Town of Montgomery Police Station

ADDENDUM #3: April 25, 2025

Drawing: FIRST FLOOR FURNITURE PLAN

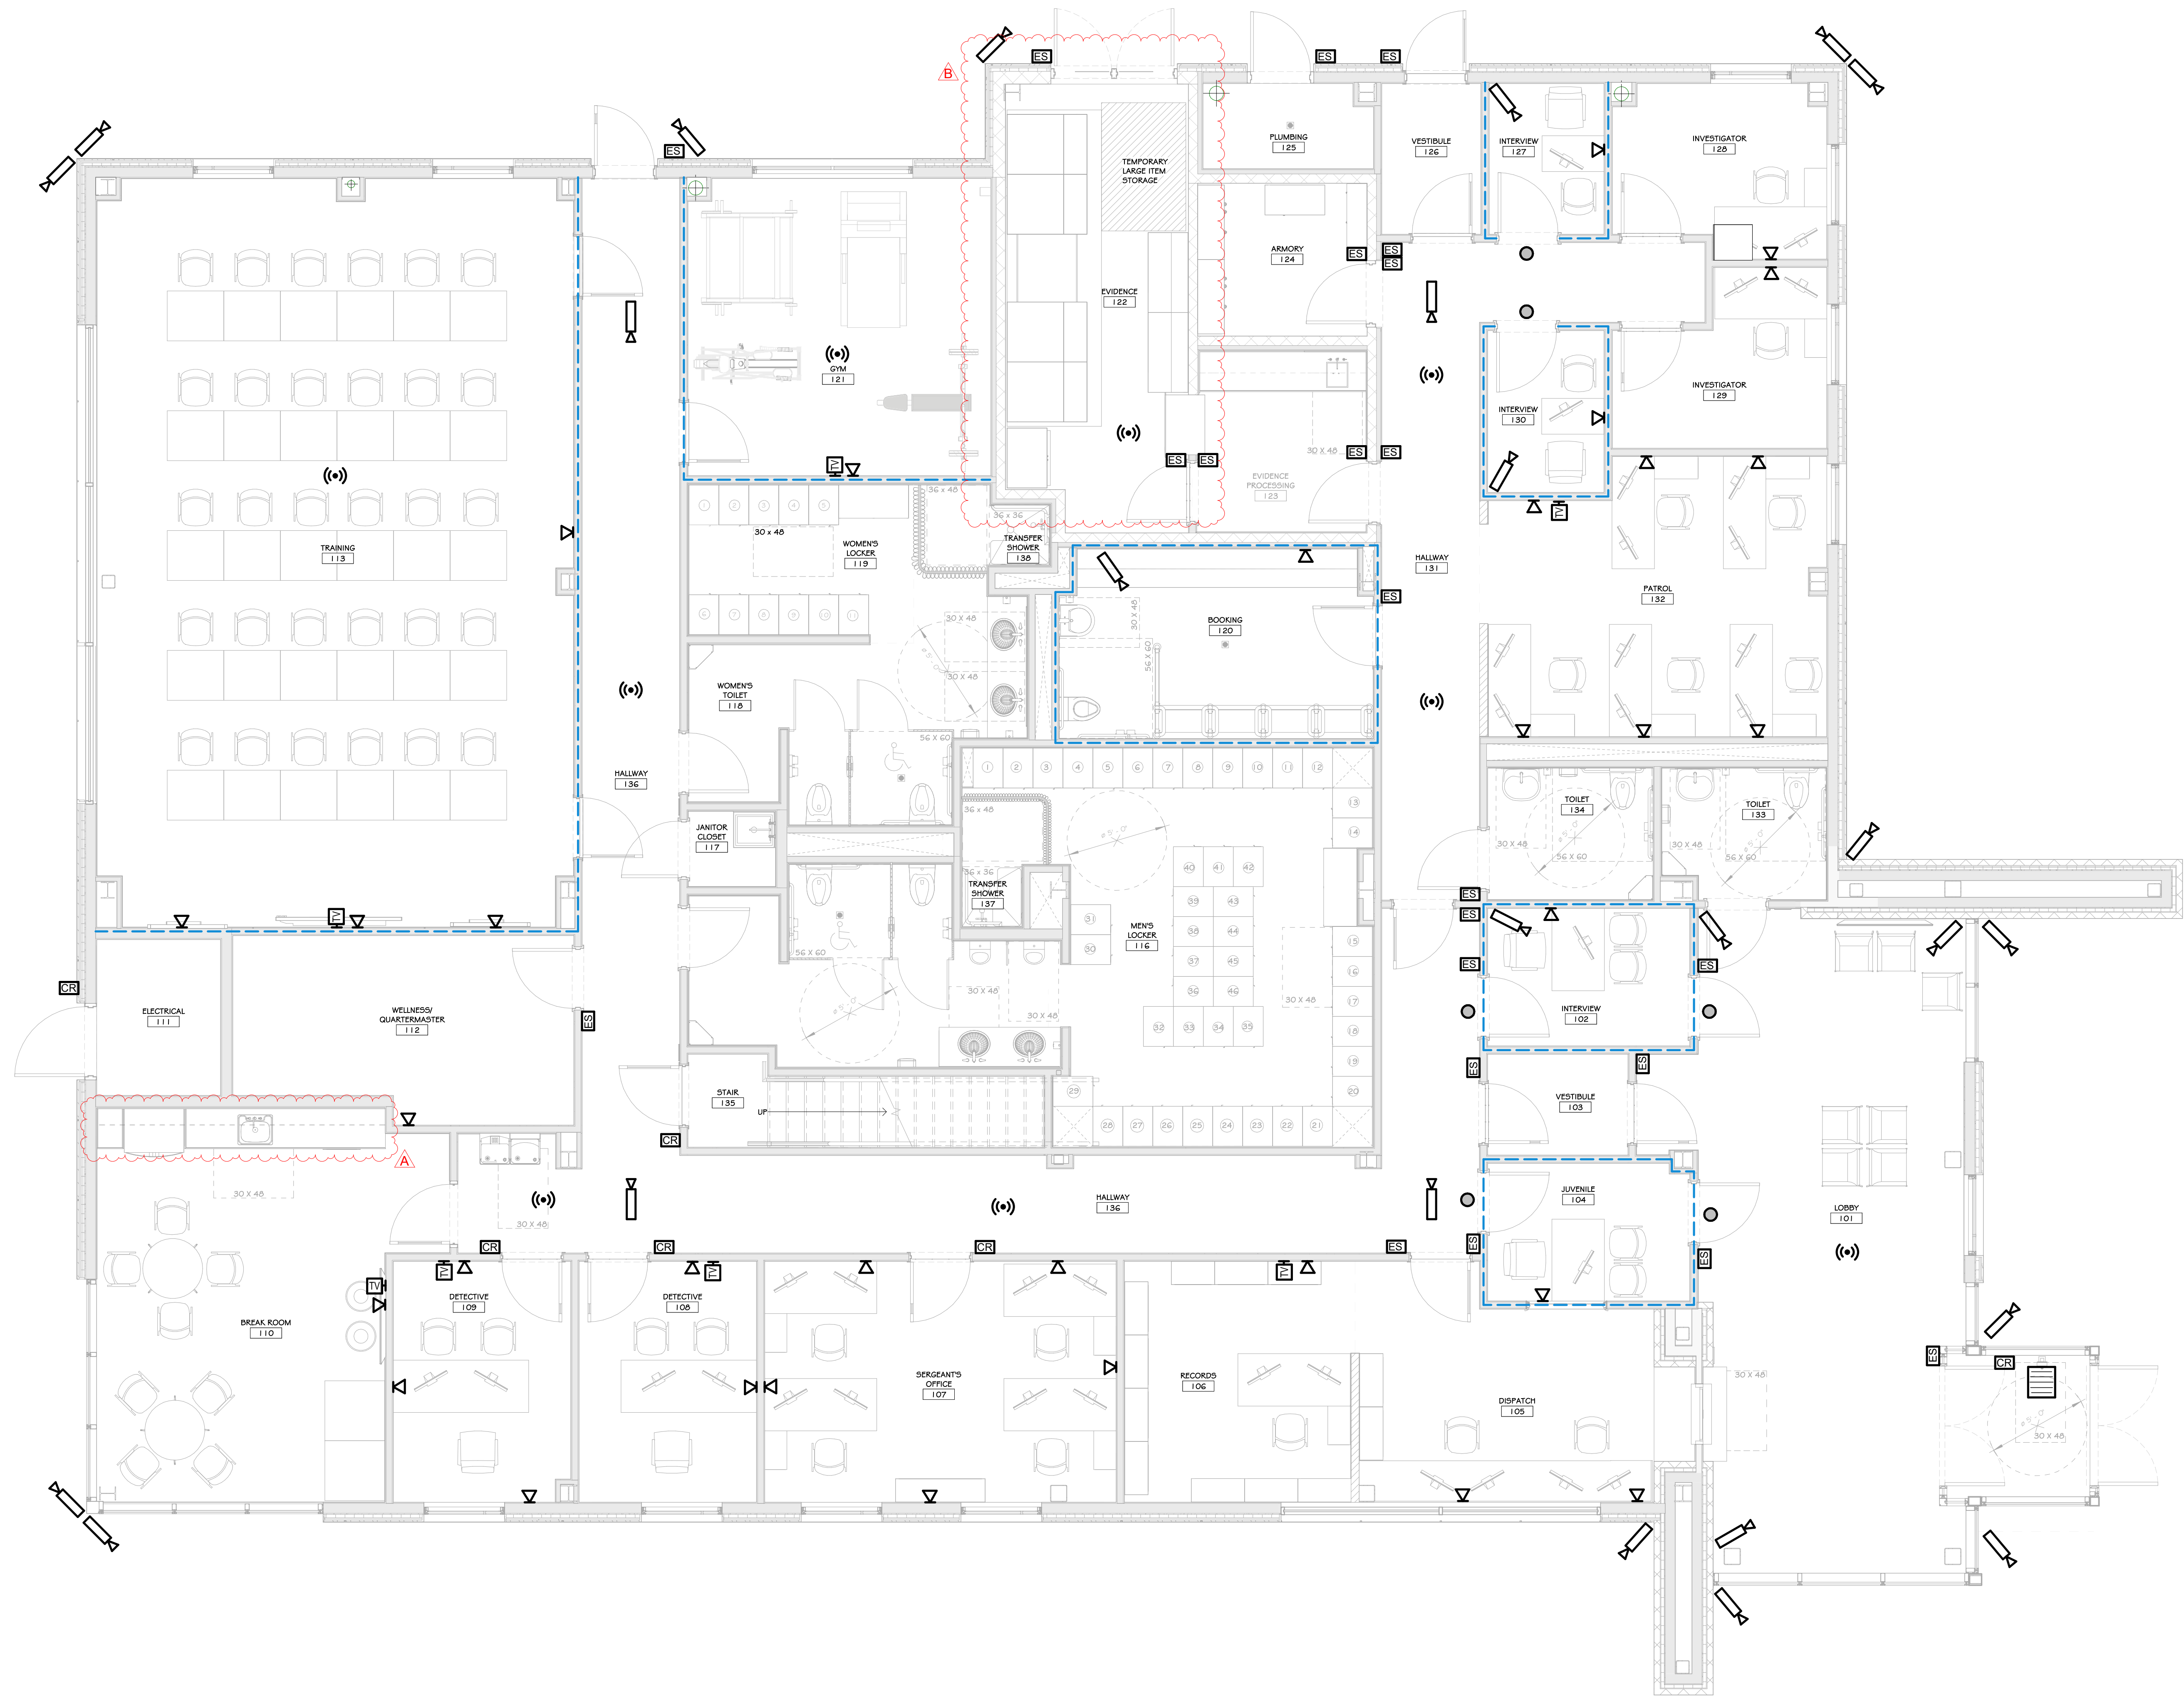
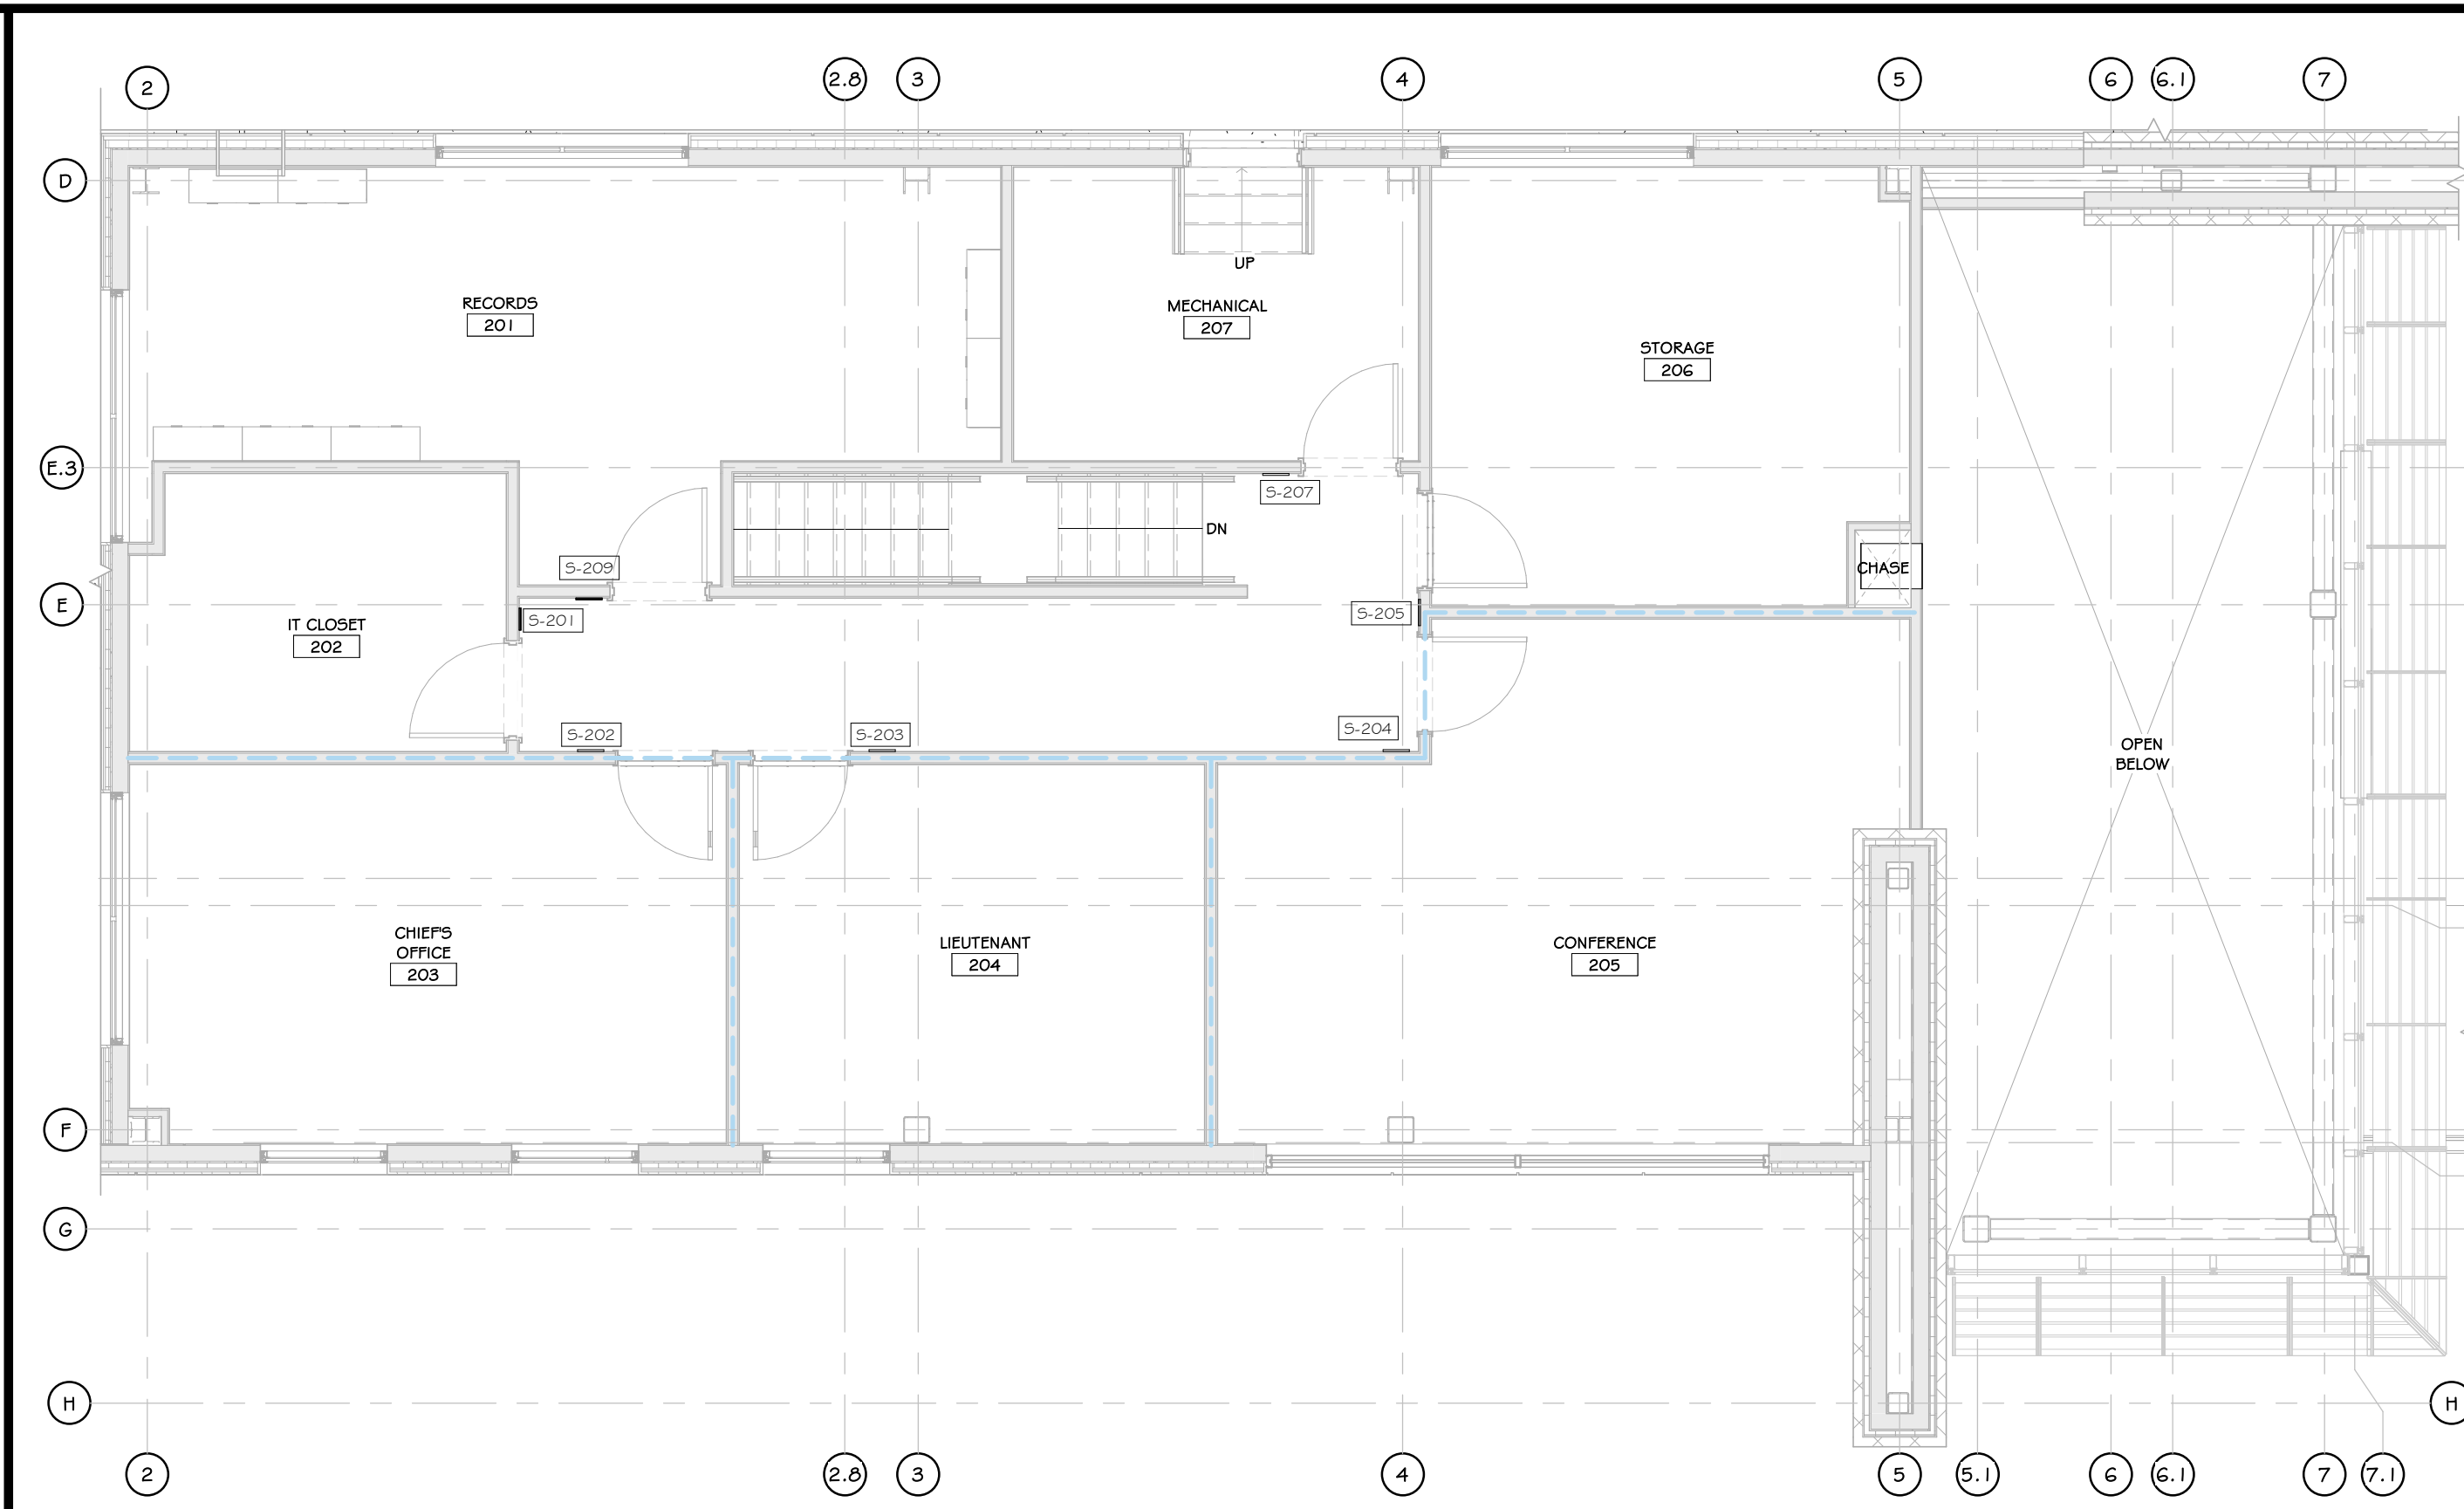
5. **As a notification**, A-201 - First Floor Plan, A-700 - First Floor Finish Plan, A-703 - First Floor Paint Plan, A-800 - Doors & Window Schedule, A-900 - First Floor Furniture Plan, A-902 - Interior Sign Schedule, and A-903 - First Floor were updated.
